STAFF RECOMMENDATION
1513 Elmwood Avenue
January 17, 2018

Application: New construction-addition
District: Belmont-Hillsboro Neighborhood Conservation Zoning Overlay
Council District: 18
Map and Parcel Number: 10416038600
Applicant: Brittney Mount, Allard Ward Architects
Project Lead: Paul Hoffman, paul.hoffman@nashville.gov

| <p>Description of Project: Application to add a rear addition and deck to a contributing building.</p> <p>Recommendation Summary: Staff recommends approval of the proposed addition, with the condition that Staff have final approval of roofing color, windows and doors. With this condition, Staff finds that the project meets Sections II.B.1 and II.B.2 of the Belmont-Hillsboro Neighborhood Zoning Overlay design guidelines.</p> | <p>Attachments A: Photographs B: Site Plan C: Elevations</p> |

Figure 2: 1513 Elmwood, right side. Existing dormer is minimally visible.

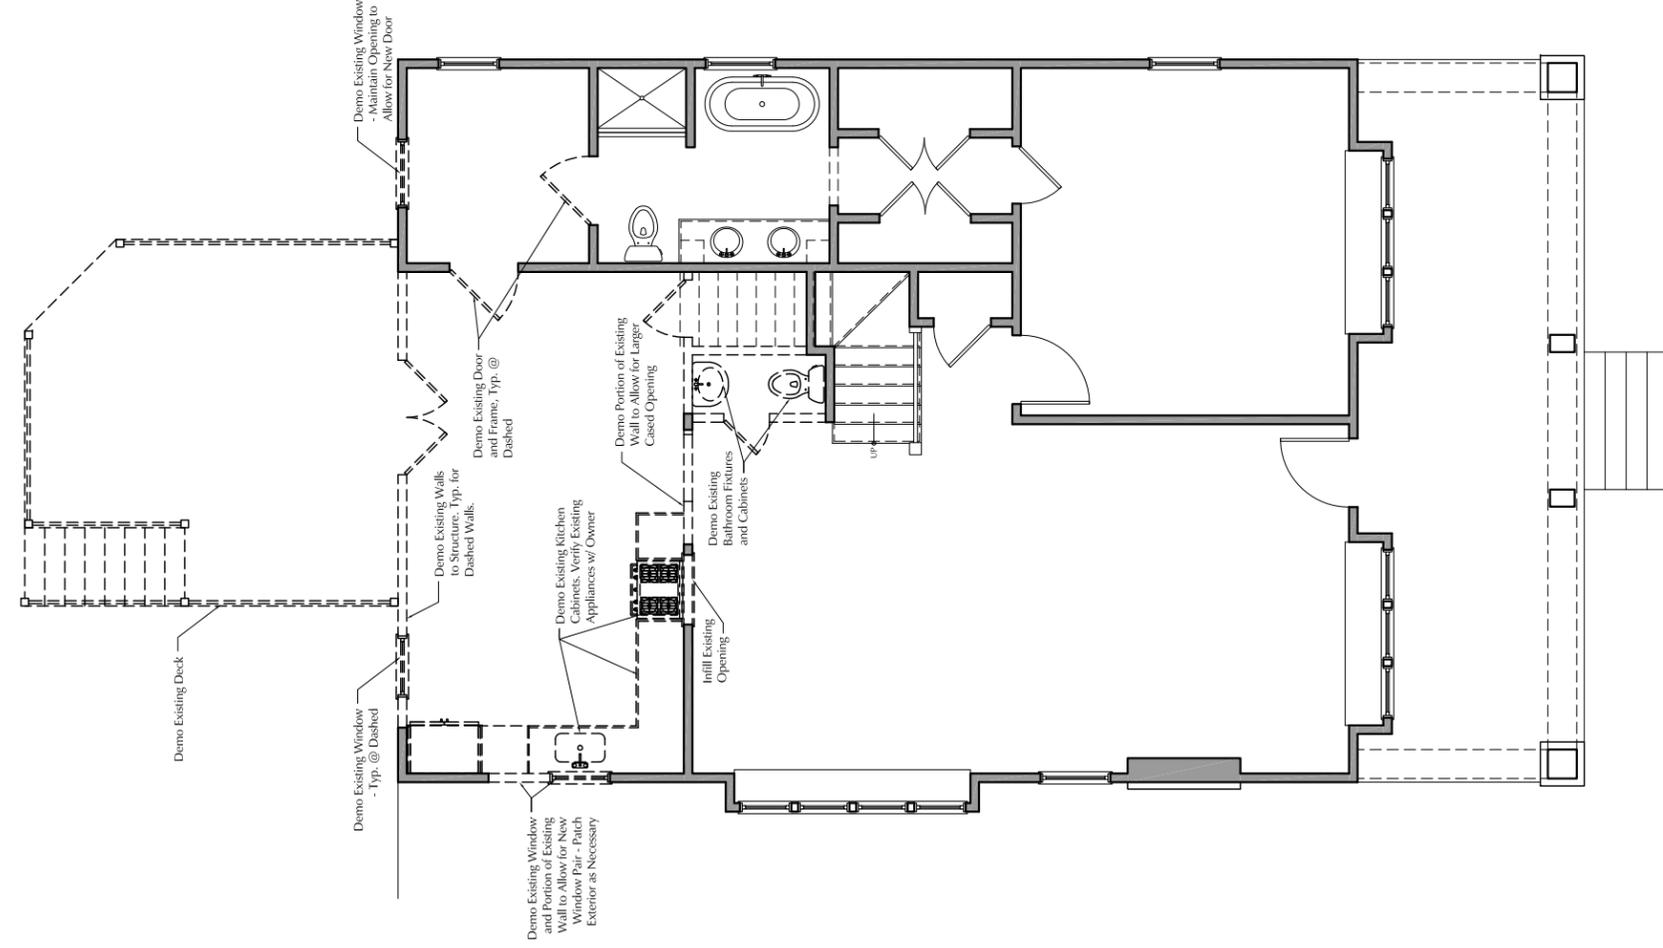
Partial Demolition: An existing rear deck and the majority of the rear wall will be removed. Two upper-level side window openings will be resized.

Removal of the rear wall is typical of rear additions and appropriate because the rear corners will be retained, the rear wall is not historic, and it is not a character defining feature. The rear dormer windows are likewise not a character-defining feature, they are not historic, and have minimal visibility so their removal and replacement meets the guidelines for demolition.

Drawings:
Elevations
Date:
12.29.17

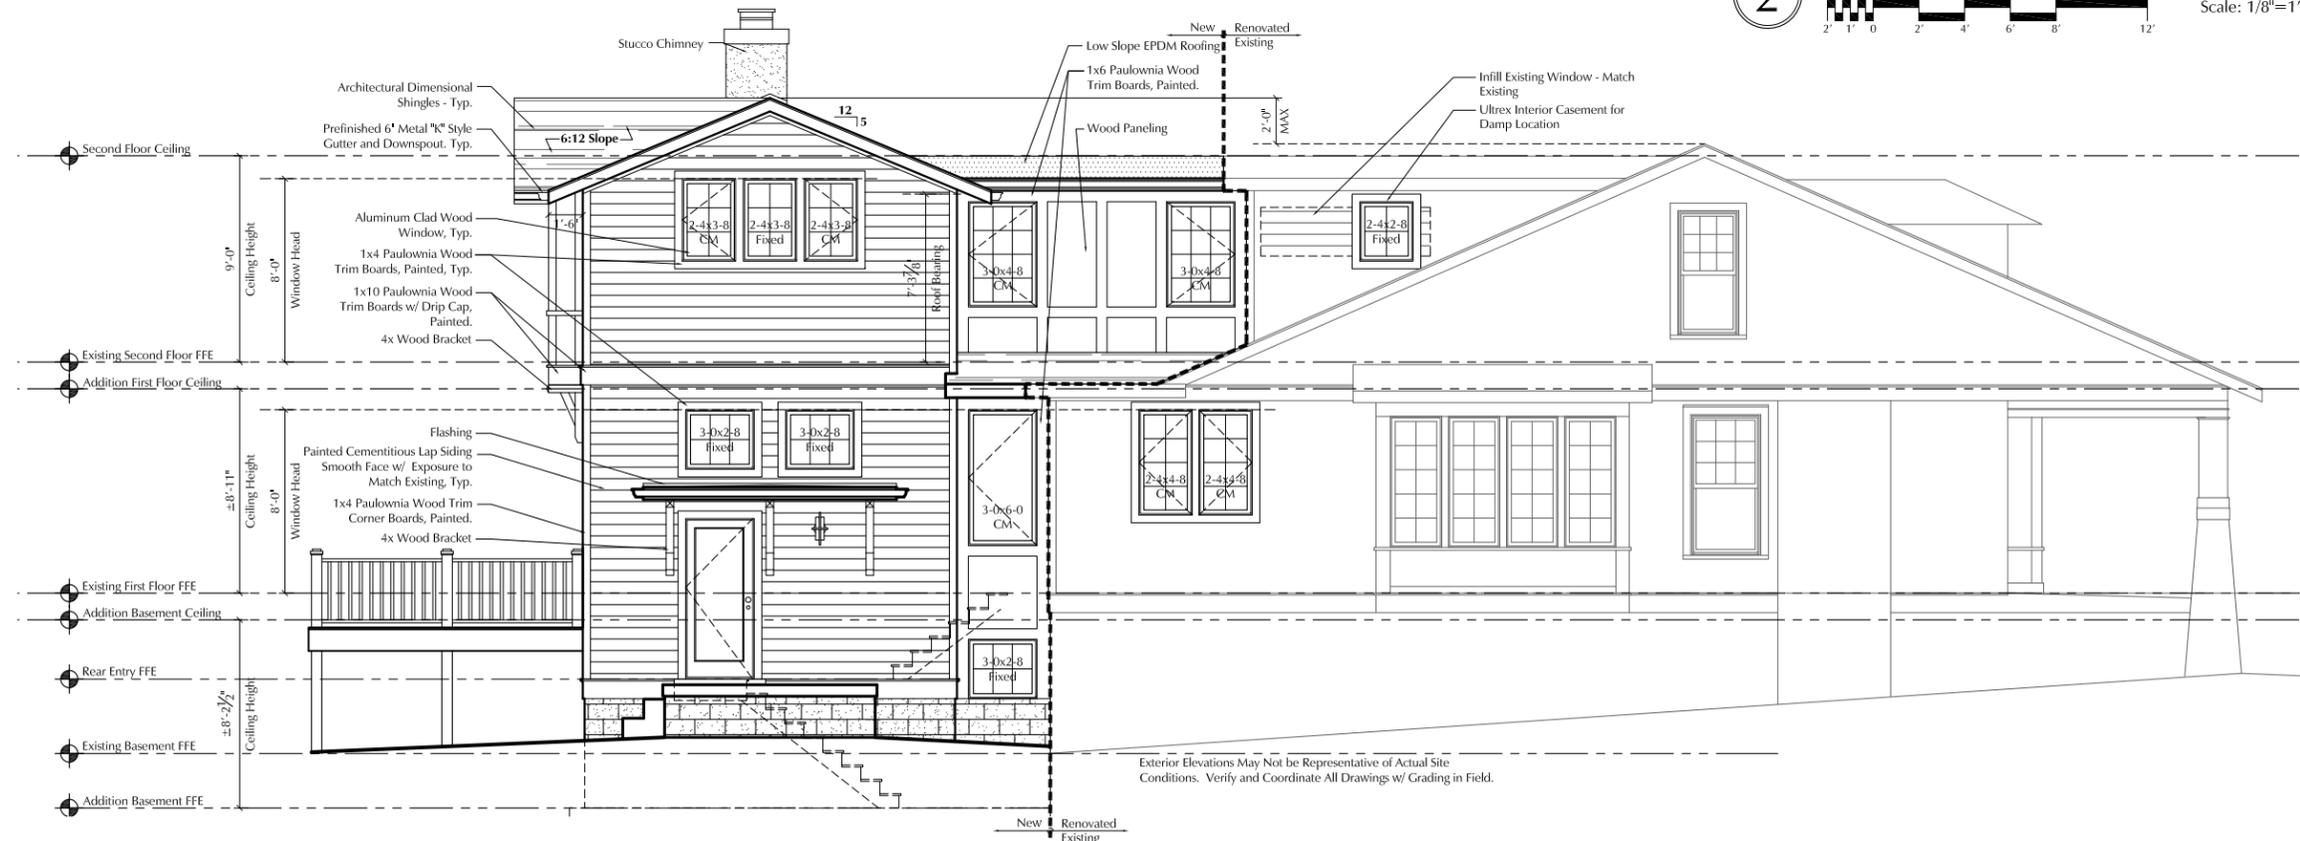
Height & Scale, Roof Form: The proposed addition is two stories with an uncovered deck at the rear. The additional footprint is approximately six hundred and twenty-five square feet (625 sq. ft.) with a one hundred and ninety square foot (190 sq. ft.) deck. The existing footprint of the house is approximately one thousand three hundred and sixty-five square feet (1,365 sq. ft.). The footprint of the addition is less than the footprint of the existing house, and the new construction is located at the rear of the historic house, in accordance with the design guidelines. The addition adds approximately twenty feet (20') to the existing depth of the house, which is fifty-two feet (52') deep.

The addition has a side-gabled roof form, with a maximum ridge height that is two feet (2') taller than the ridge of the historic house, as would have been permitted by the design guidelines with a ridge raise. Although this addition does not incorporate a ridge raise, staff finds it to be more appropriate because there is less change to the historic form of the structure and pushes the additional height further back. The change in grade on this lot allows for a full two story rear addition onto the one and a half story house. The maximum height will be at a distance of approximately sixty feet (60') from the front of

the house, and will be minimally visible. Staff finds that the two foot (2') increase in height is compatible in this case.

Proportion and Rhythm of Openings: The windows on the proposed addition are generally twice as tall as they are wide, meeting the historic proportion of openings. There are no large expanses of wall space without an opening. Staff finds the project’s proportion and rhythm of openings to meet Section II.B.1.g.
